Department of Energy  
Richland Operations Office  
P.O. Box 550  
Richland, Washington 99352

STATUS OF LIQUID EFFLUENT DISCHARGE AT THE 1325-N LIQUID EFFLUENT DISPOSAL FACILITY

This letter documents the status of effluent discharges at the 1325-N Liquid Effluent Disposal Facility (1325-N Crib) and is provided by the U.S. Department of Energy, Richland Operations Office (RL) and Bechtel Hanford, Inc. (BHI) as requested in Reference 1.

Figure 1

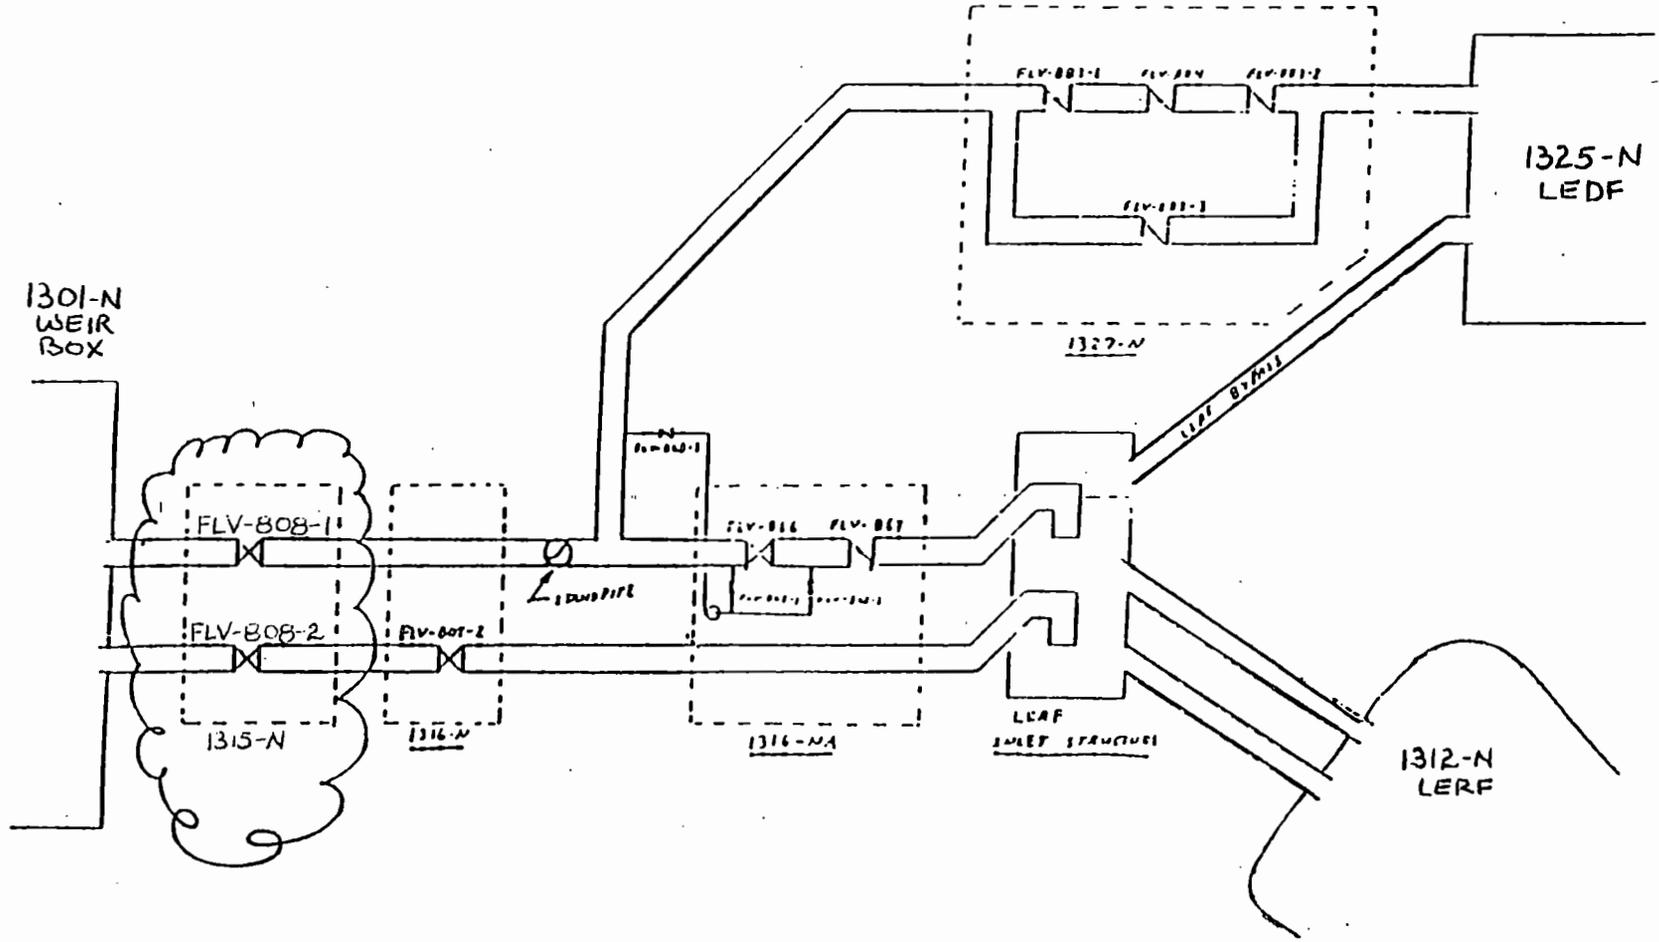
- b. The discharge rate of this water is unknown and cannot be determined, however, the volume and rate would not be sufficient to drive contaminants significantly deeper into the soil column.
  - c. The additional soil moisture will not present any physical constraints to remediation.
2. The Crib Isolation Plan dated August 4, 1993, states that all valves leading from the 105-N lift station to the 1301-N and 1325-N crib will be locked out and tagged. During our June 17, 1996, inspection, several valve handles were noted which were not locked and tagged. Please provide a report on the status of all associated valve workings required to be locked out and tagged.

Response: The Crib Isolation Plan focused on the 1325-N Crib and stated that future discharges to the crib could be precluded by closing one specific valve (FLV-808-1). As shown in Figure 1, this valve is located in the line directly between the 1301-N Weir Box and the 1325-N Crib. A second line goes from the weir box to the liquid effluent retention facility inlet structure. Because effluent could be diverted from the inlet structure to the 1325-N Crib, it is also necessary to close the second line. This is accomplished by closing valve FLV-8058-2 (closure of this valve was not identified in the plan). Closure of both these valves and removal of the handwheels is documented in the task worksheet and lockout form (Attachments 1 and 2) and a message from Mr. R. J. Gimera to Mr. J. P. Collins (Attachment 3). Although not required by the plan, RL also identified the last valve in each line discharging to the weir box as candidates to be closed and tagged (Attachment 4). The weir box served as the collection point for effluent going to the 1301-N and 1325-N Cribs. Closing these valves supported isolation of the 1301-N Crib. The valves associated with the 1301-N and 1325-N Cribs that were closed and tagged consist of the following:
